Contract #: 04-0120F4
 Cty: SF/ALA Rte: 80 PM: 13.2/13.9
 File #: 69.25B

QUALITY ASSURANCE -- NON-CONFORMANCE REPORT

Report No: NCR-000955

Reference Description: Excessive Root Opening on PJP Welds for Lift 13AE Saddle Grillage Wing Plates

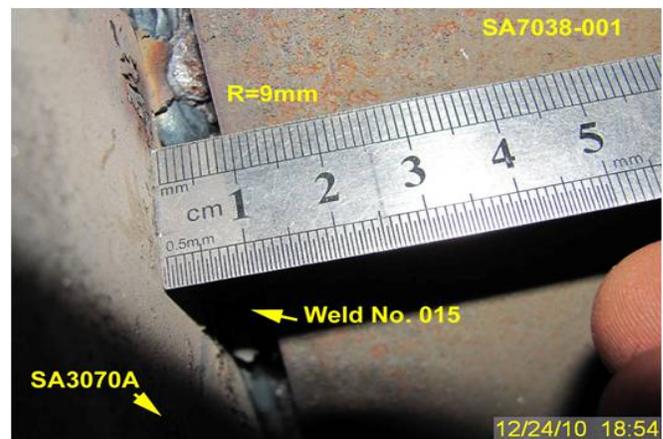
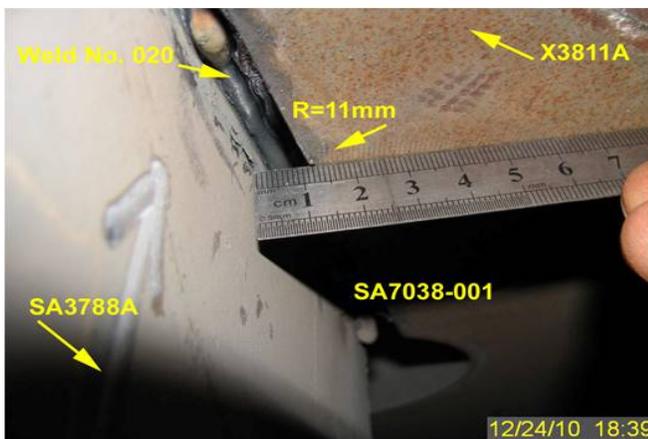
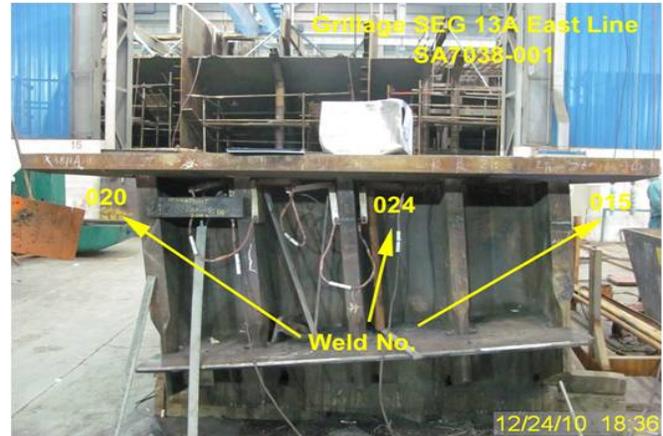
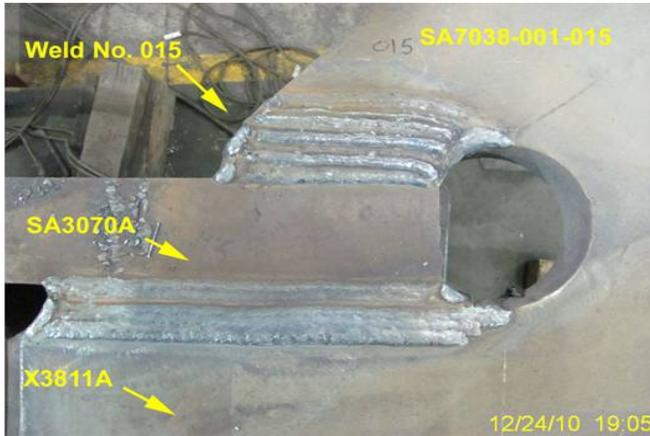
- The connection plate (X3811A) to the Grillage Plate A (X3788A, X3787A, X3786A) Partial Joint Penetration corner welds with root openings between 9mm to 11mm in a total of three (3) locations.
 - The maximum allowable root opening per the applicable WPS is 3mm as fit up.
 - The affected welds are designated as SA7038-015, 020 and 024.
 - The welds are designated on the contract drawings as Seismic Performance Critical Members (SPCM), and require through thickness properties (TTP).
 - The members are located in OBG fabrication Bay 13.
- See attached photographs for additional detail.

Contractor will finish the weld according to the approved RFI 921. Contractor will submit a NDT report to prove the weld is acceptable. In addition, to prevent this type of NCR, where feasible attempts will be made to resolve fit up issue prior to proceeding with work.

Contractor finished the weld according to the approved RFI 921. The weld has been changed from PJP to CJP. However Contractor requested UT on this weld to be waived and the request has been accepted. MT report submitted, and the report shows the weld is acceptable.

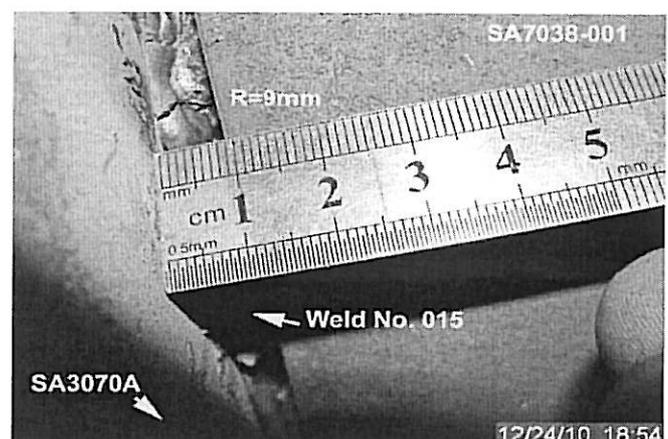
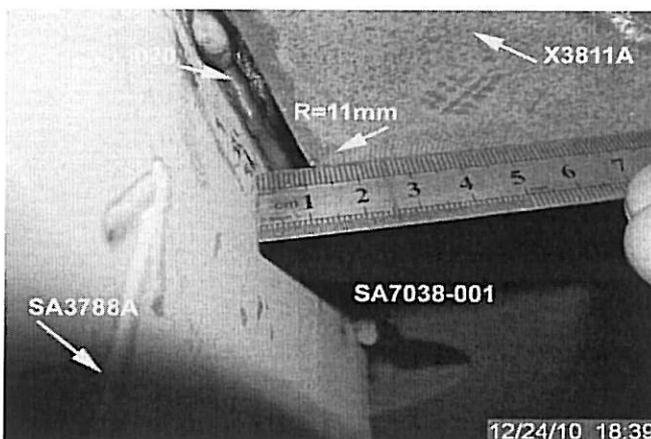
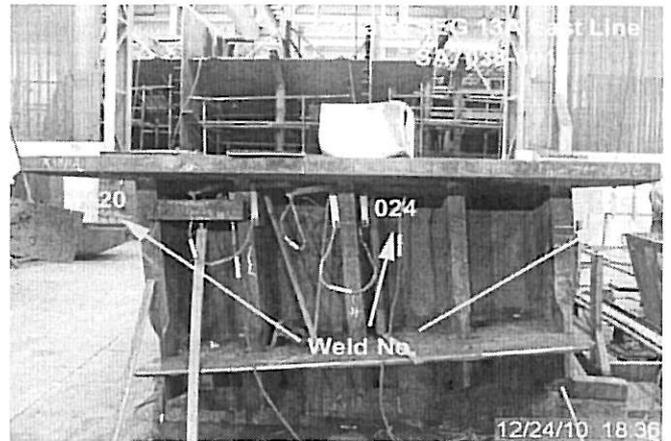
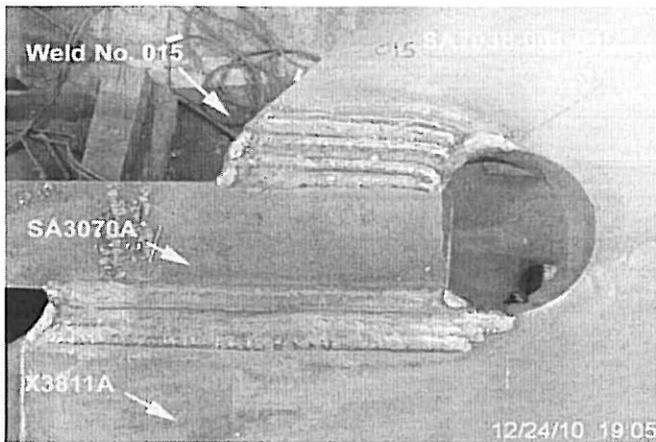
- The connection plate (X3811A) to the Grillage Plate A (X3788A, X3787A, X3786A) Partial Joint Penetration corner welds with root openings between 9mm to 11mm in a total of three (3) locations.
 - The maximum allowable root opening per the applicable WPS is 3mm as fit up.
 - The affected welds are designated as SA7038-015, 020 and 024.
 - The welds are designated on the contract drawings as Seismic Performance Critical Members (SPCM), and require through thickness properties (TTP).
 - The members are located in OBG fabrication Bay 13.
- See attached photographs for additional detail.

The proposal to change the PJP welds noted in the attachments to be out of root gap tolerance to CJP welds with 100% MT of the backgouge and 100% MT of the finished weld is acceptable
